World Forum for Harmonization of Vehicle Regulations

Proposal for Supplement 8 to the 06 series of amendments to Regulation No. 16 (Safety-belts, ISOFIX and i-Size)

Supplement 8 to the 06 series of amendments to Regulation No. 16 (Safety-belts)

Figure 2

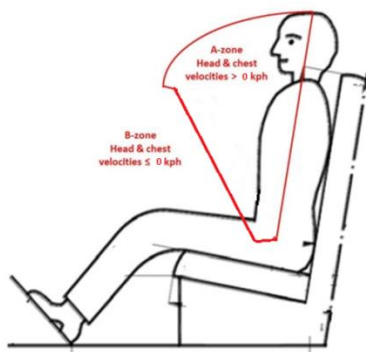
Annex 1B, insert new item 12.1., to read:

"12.1. In case a restraint system has been granted/refused/extended/withdrawn,² those can be used for particular types of vehicles compatible with the following dimensional conditions: no interior part in a quoted A-zone as shown below (Figure 2):

"Figure 1
Specifications of the fixture (all dimensions in mm)

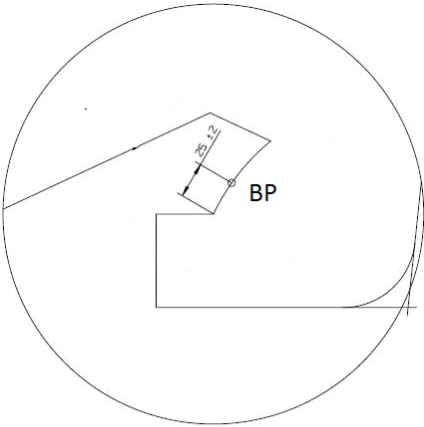
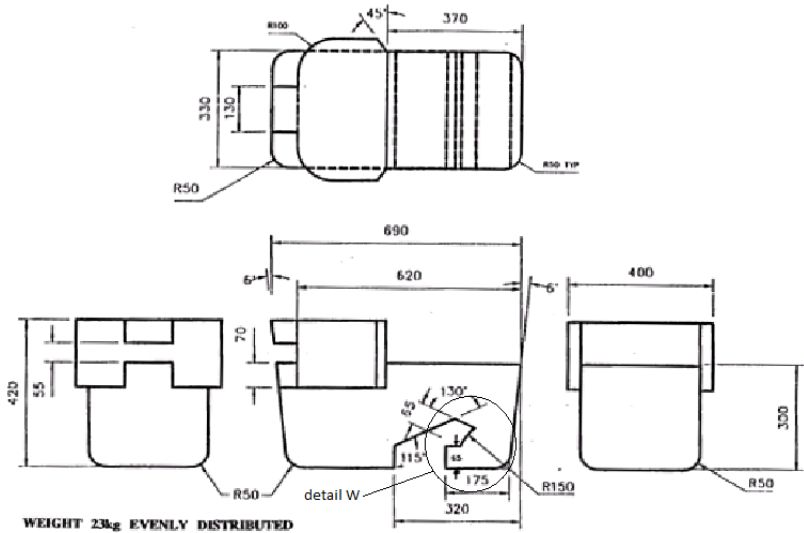
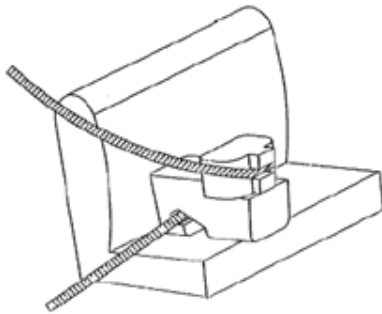
"3.2. The lap portion of the belt shall touch the fixture on both sides at the rear of the lap belt path (see Figure 3). The seat belt webbing shall always cover the points BP on the left and right ends of the curved edge; the exact position of point BP on the curved edge is indicated in detail W of Figure 1."

Figures 1 to 3, amend to read:
